**Proposed Temporary Cold Storage for Poultry and Distribution Centre for a Period of 3 Years with Filling of Land in “Agriculture” Zone, Lots 471 S.B RP (Part), 472, 473, 474, 475, 476, 482 RP, 483, 484, 486, 487 RP, 497 S.A RP, 501, 502, 504 S.B, 505 and 506 S.B RP in D.D. 89 and Adjoining Government Land, Man Kam To Road, Sha Ling (Compliance with Approval Condition (o) for Planning Application No. A/NE- FTA/201)**

**Re: Section 16 Planning Application for Proposed Temporary Cold Storage for Poultry and Distribution Centre and Filling of Land for a Period of 3 Years at Lots 471 S.B RP (Part), 472, 473, 474, 475, 476, 482 RP, 483, 484, 486, 487 RP, 497 S.A RP, 501, 502, 504 S.B, 505 and 506 S.B RP in D.D. 89 and Adjoining Government Land, Man Kam To Road, Sha Ling, New Territories  
(Approval Conditions (o) of Planning Application No. A/NE-FTA/201)**

**Responses-to-Comments**

## D02 – Drainage Impact Assessment Report

Figure 3-2: Indicative Proposed Drainage Layout

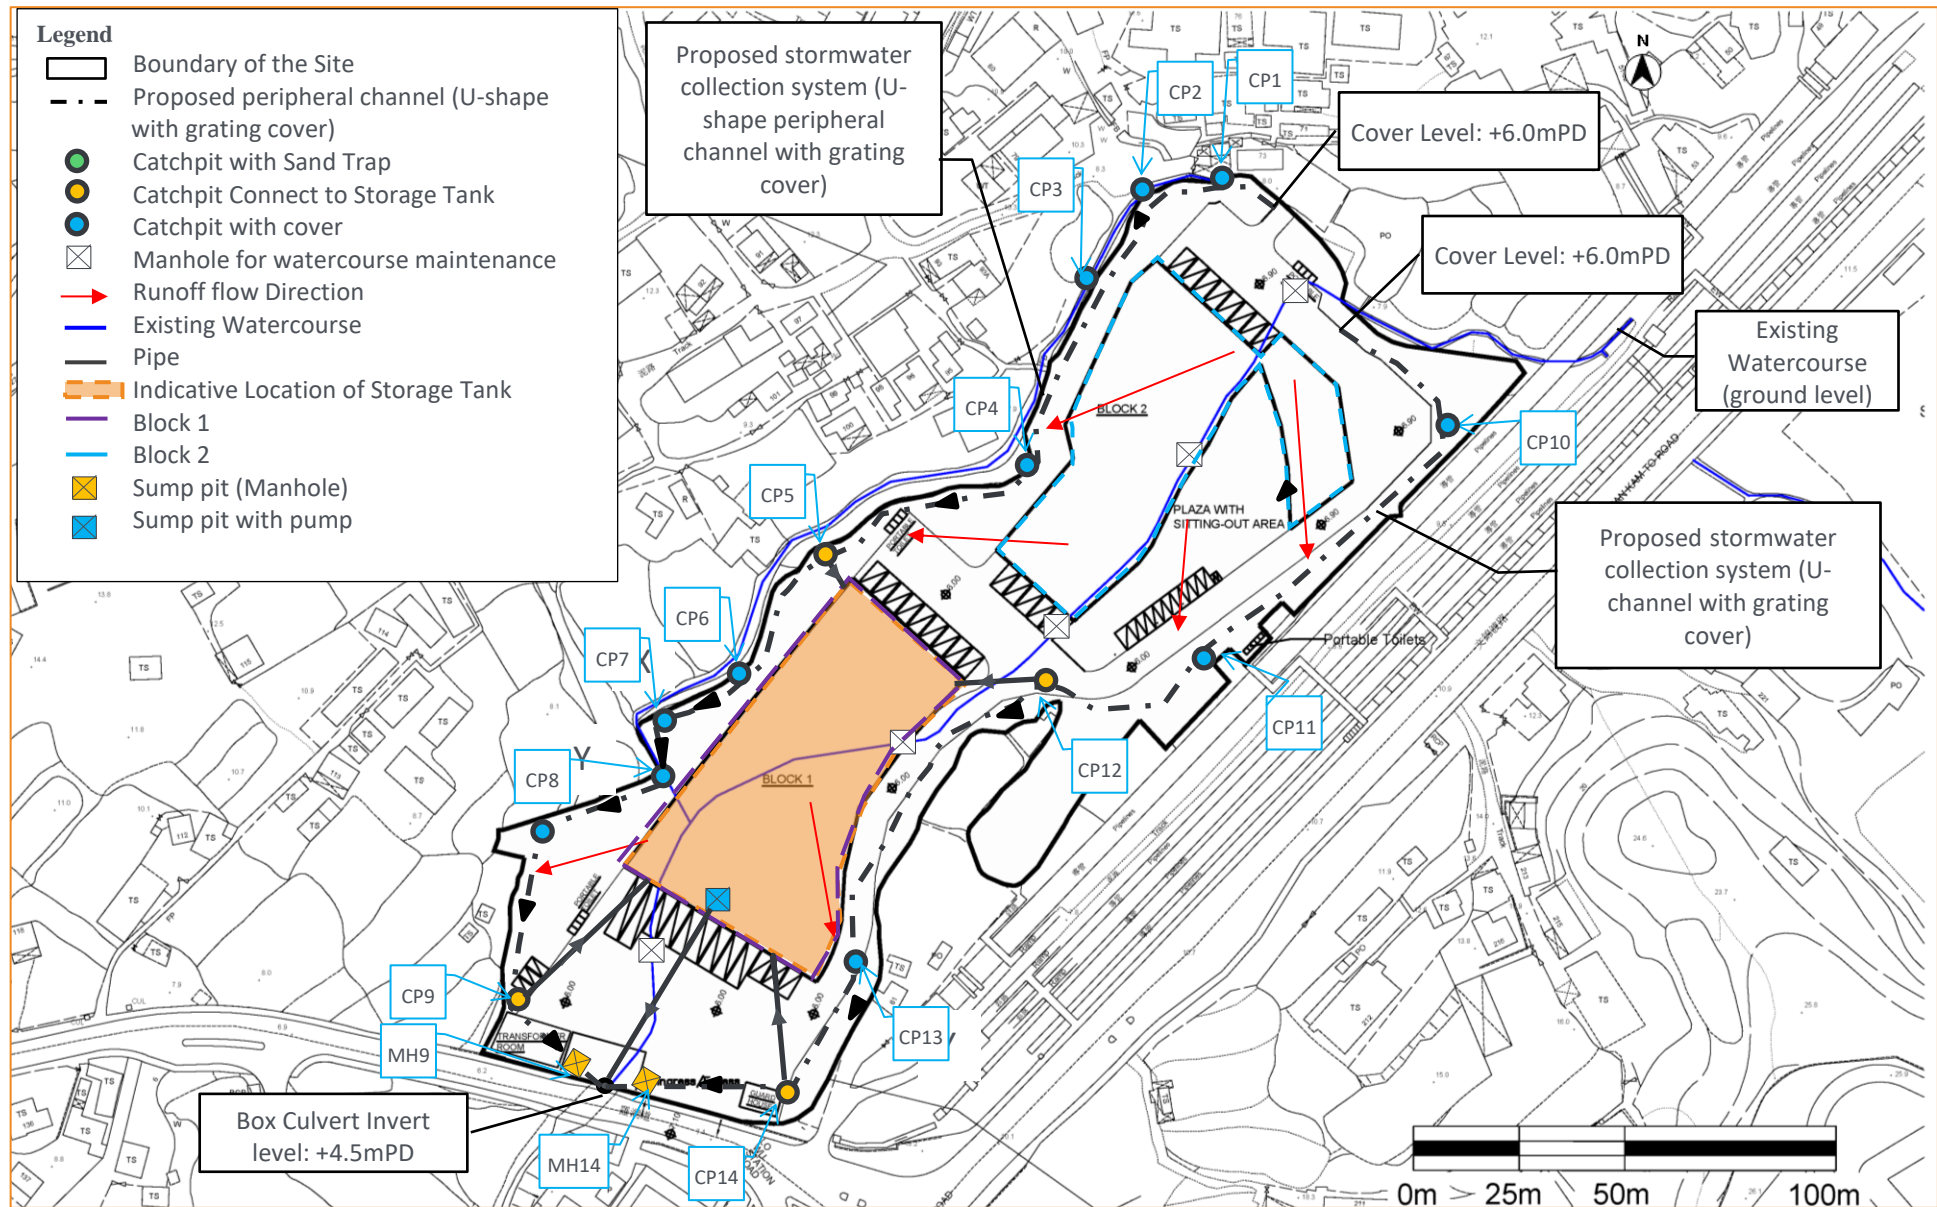
boundary;	
	(ii) a drainage plan should be provided clearly showing the size, levels and routes of the proposed drainage. The details (invert level, gradient, general section etc.) of the proposed drain/ surface channel, catchpits and the discharge structure shall be provided;	(ii) The proposed drainage layout is provided in Figure 3.2. Details of the proposed channel including the size, levels, gradient are presented in Appendix D. General section of the u-channel is presented in Appendix C.
	(iii) the cover level of proposed channels should be flush with existing adjoining ground level;	(iii) Noted.
	(iv) a catchpit with covers should be provided where there is a change of direction of the channel/drain. The details of the catchpit with covers shall be provided;	(iv) Noted. Catchpit with covers will be provided where there is change of direction. Typical detail of the catchpit with cover is provided in Appendix C.

**CATCHPIT WITH TRAP**  
**(SHEET 1 OF 2)**

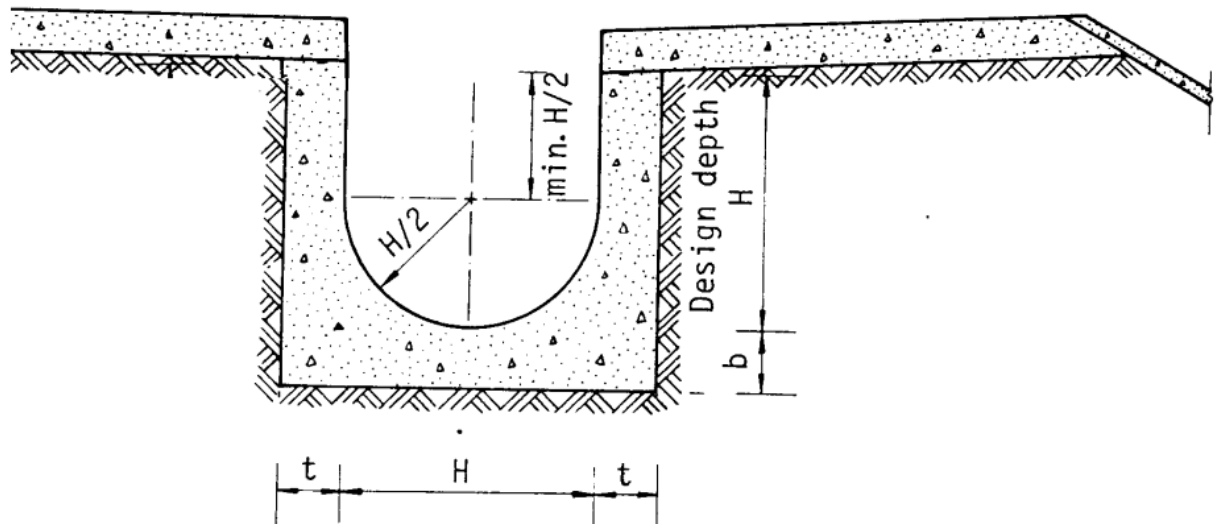
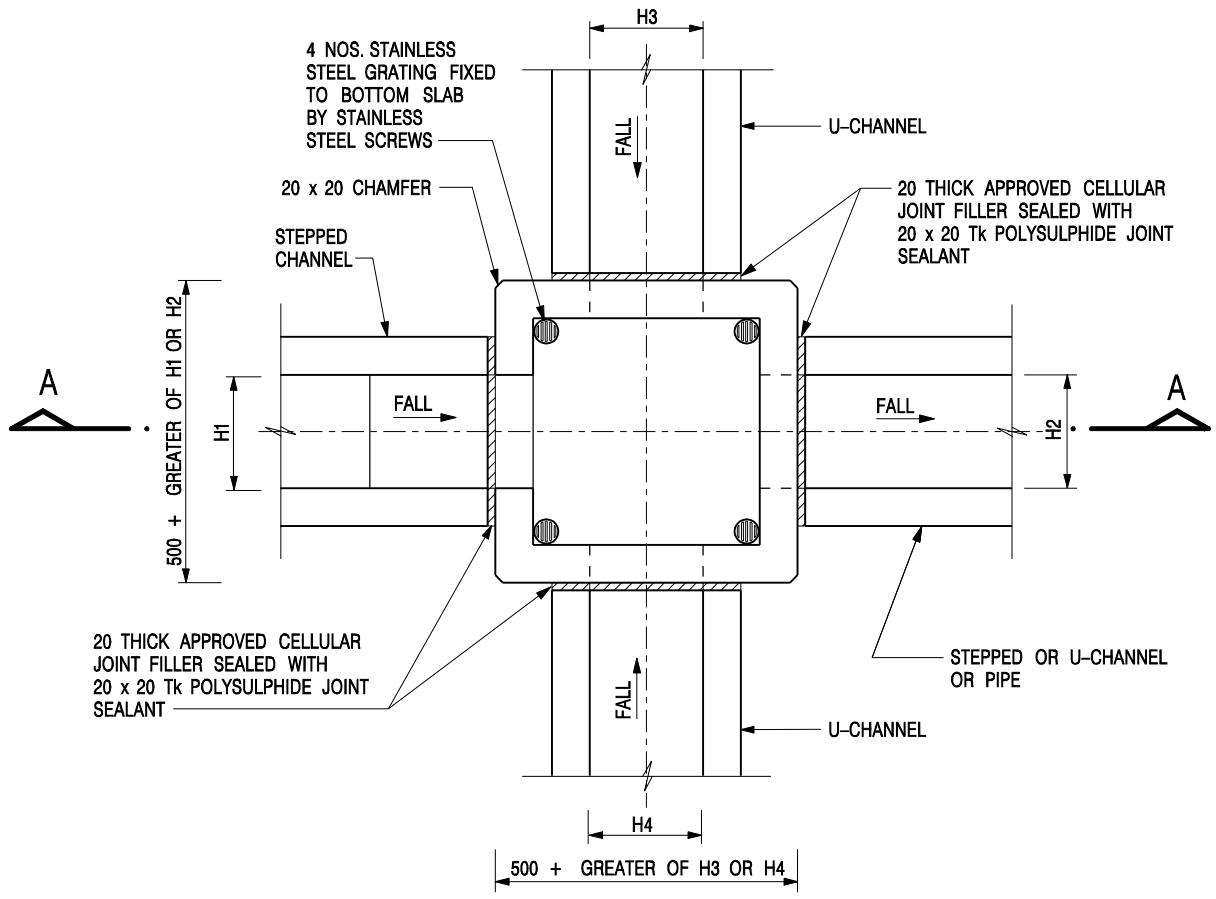
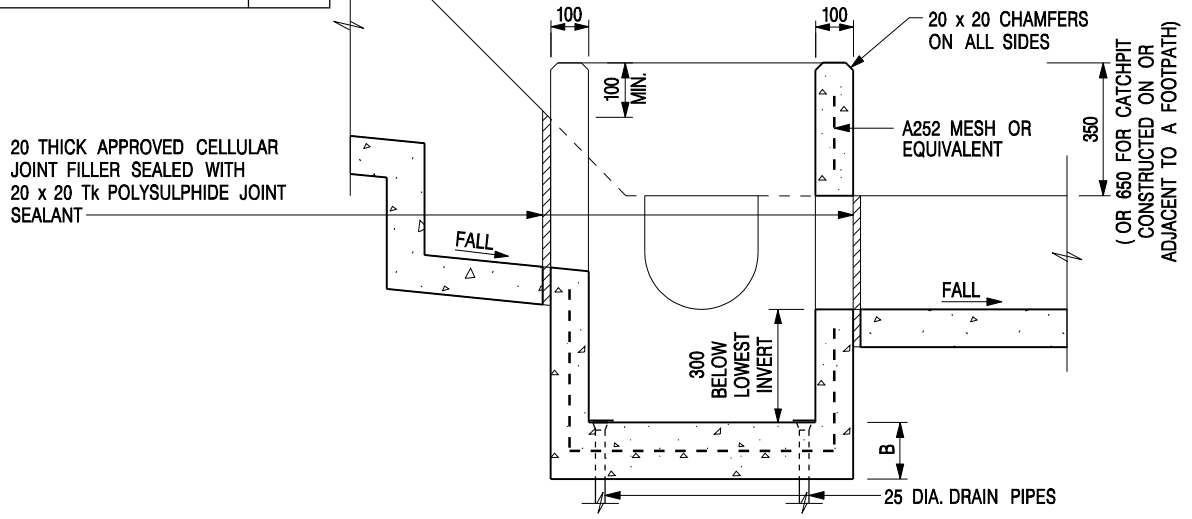
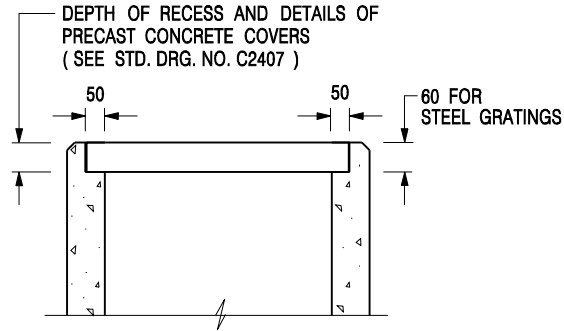
(v) catchpits with sand trap shall be provided at the outlets of the proposed drainage	(v) Noted. Catchpit with sand trap will be provided at the outlet of the proposed drainage. Typical detail of the catchpit with sand trap is

system. The details of the catchpit with sand trap should be provided; and	provided in C.
	(vi) the applicant is reminded that where walls are erected or kerbs are laid along the boundary of the same, peripheral channels should be provided on both sides of the walls or kerbs, and/or adequate openings should be provided at the walls/kerbs, to allow existing overland flow passing through the site to be intercepted by the drainage system of the site with details to be agreed by DSD, unless justified not necessary.	(vi) Noted. The site boundary will be fenced with chaining fence. Noise barriers will be erected along a section of the Site boundary. Adequate opening will be provided as appropriate to allow existing overland flow passing through.
